Preliminary /
Final
Drainage
Report

Koinonia Ranch

Project No. 61148

PCD File No. SP-21-004

DETERMINATION OF CULVERT HEADWATER AND OUTLET PROTECTION

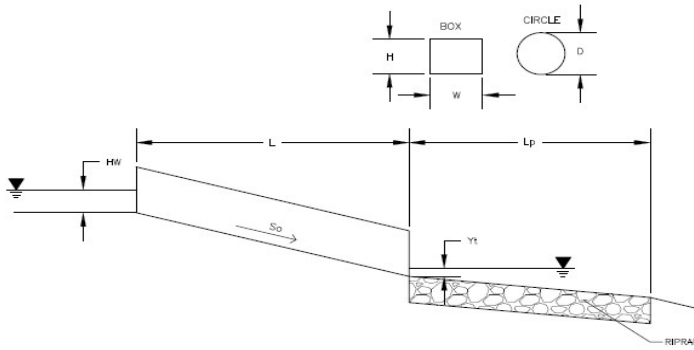
Velocities exceed maximum velocities allowed. Please state what type of protections or linings will be installed to reduce ditch velocity.

MVE PROJECT 61148
MVE DRAWING EX-DRN

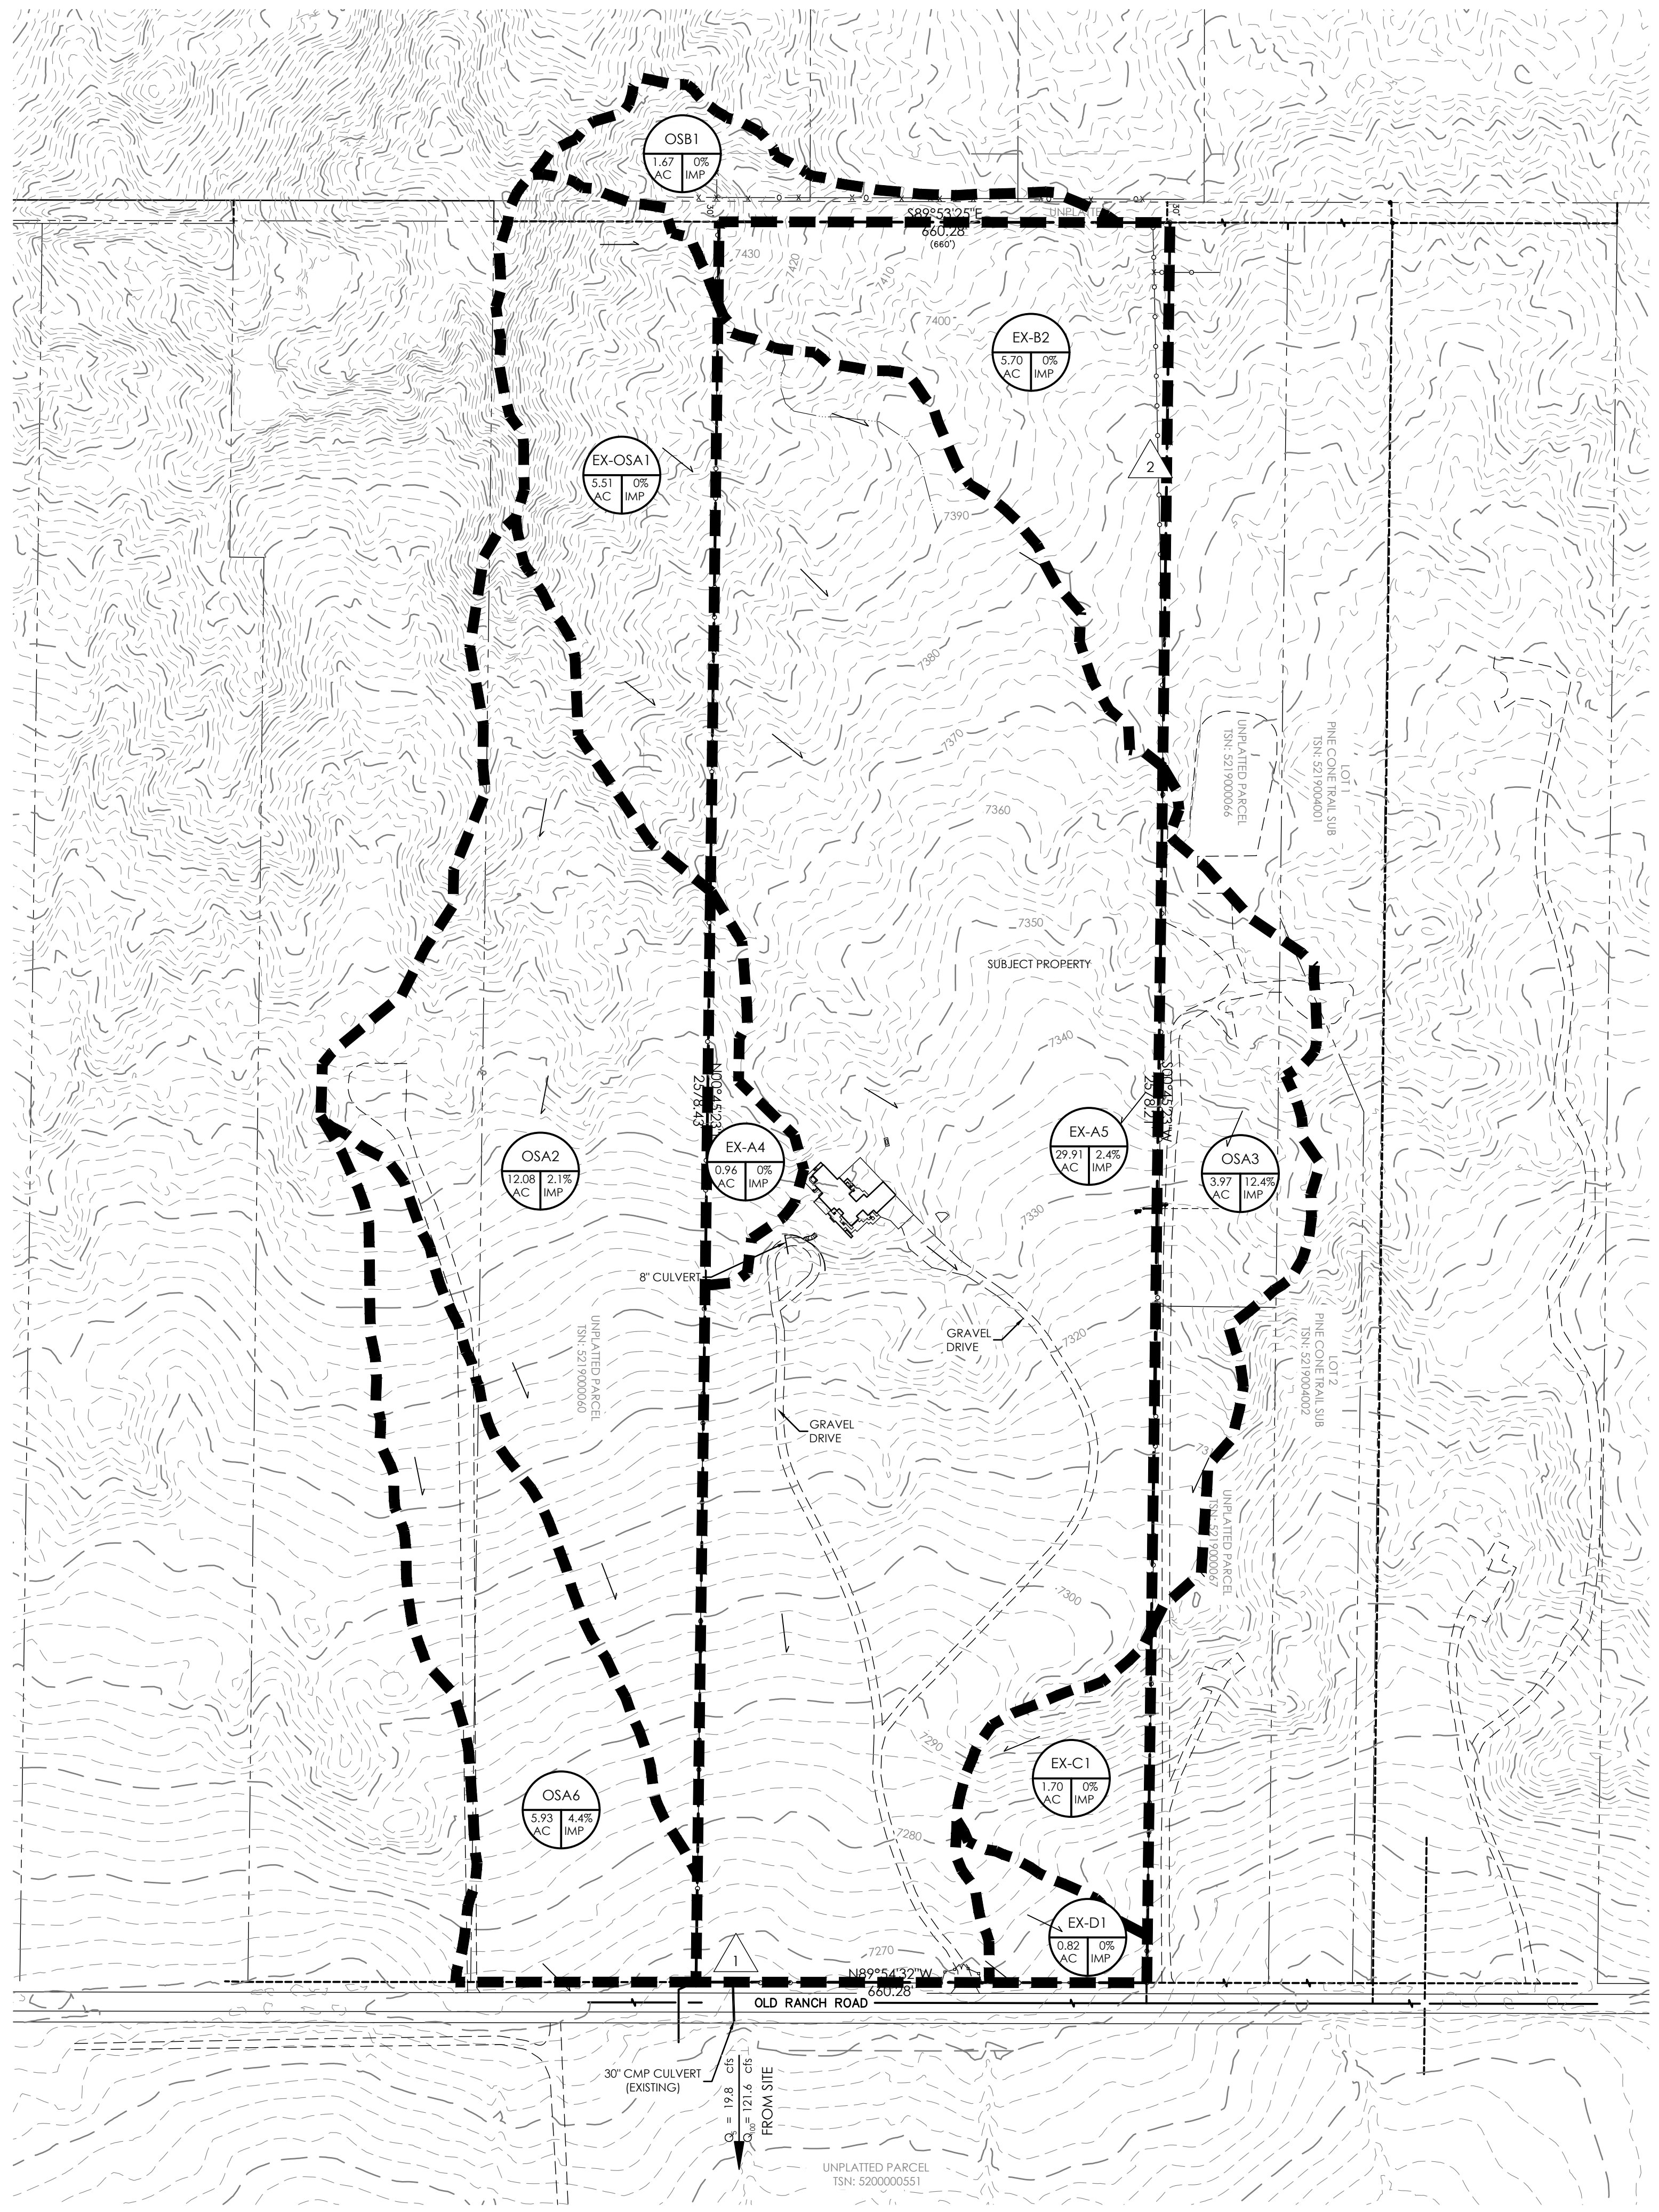
Verify highlighted sub-basins. The existing conditions drainage map shows different basins than those described in the narrative. Please revise.

Unresolved Review 2 Comment:
- Show path of time of concentration.

MVE PROJECT 61148
 MVE DRAWING PP-DRN

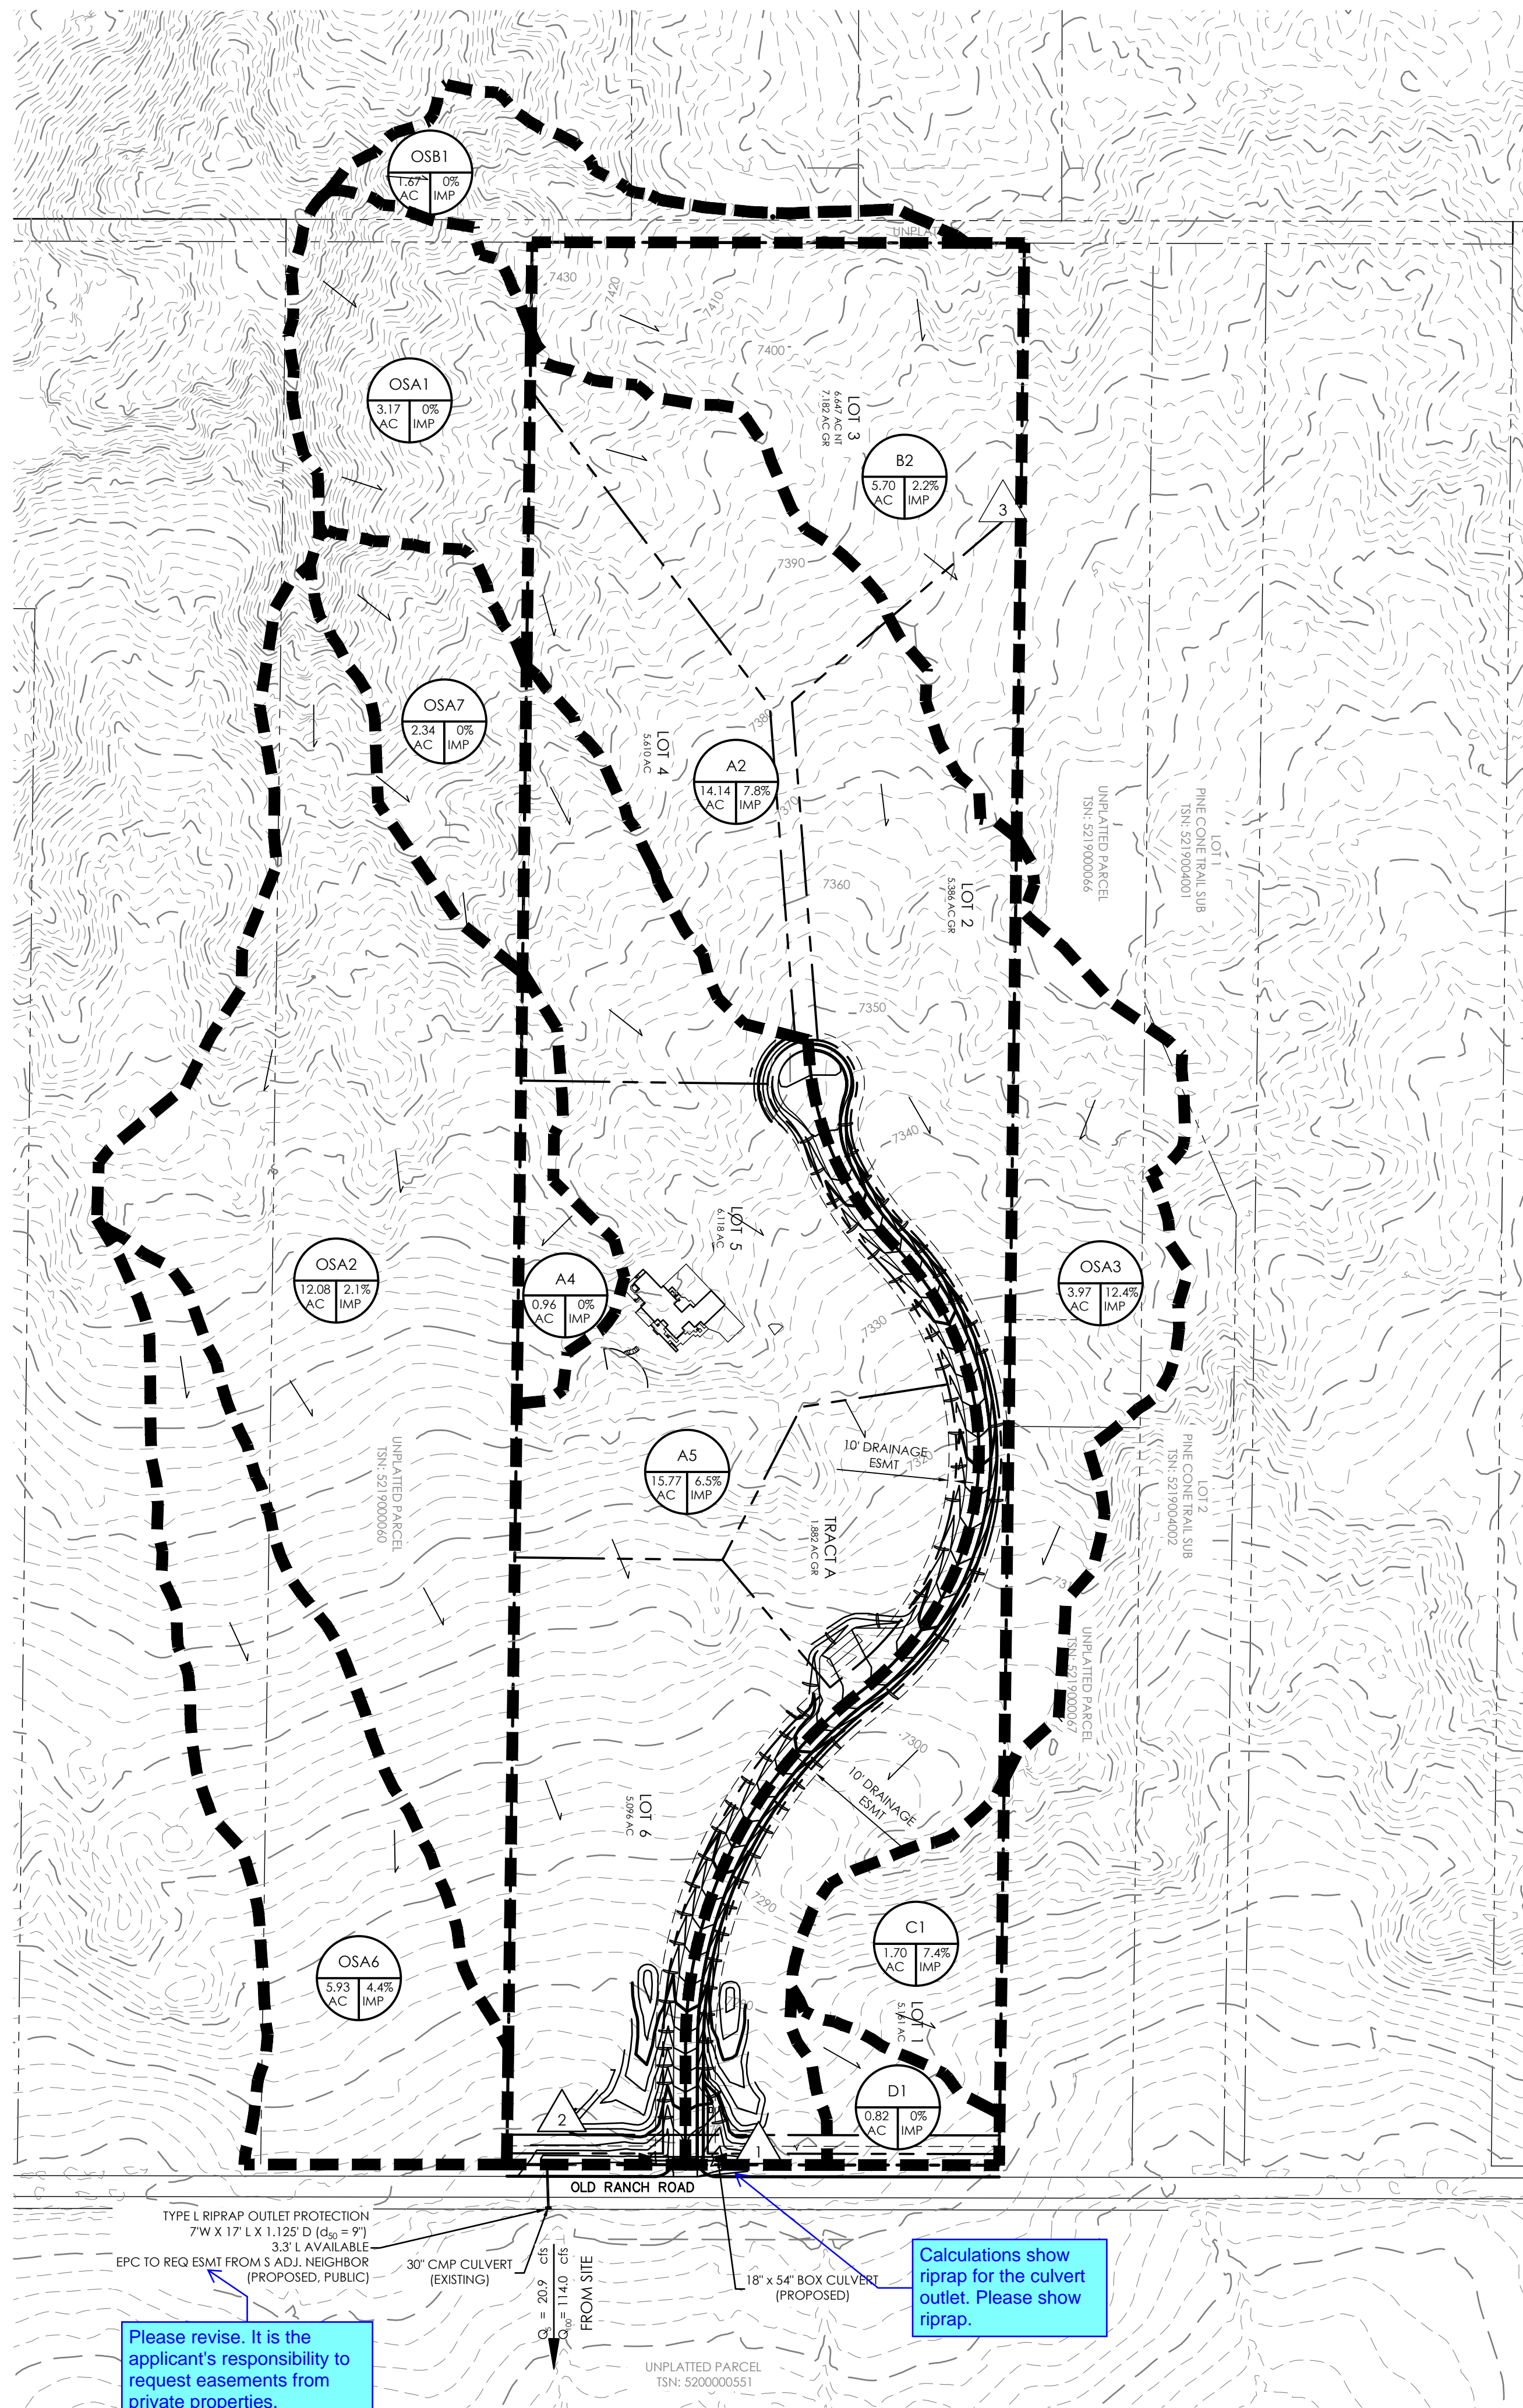
Unresolved Review 2 Comment:
 - Show path of time of concentration.

Please verify runoff values. These do not match values described in the narrative.

Please revise. It is the applicant's responsibility to request easements from private properties.
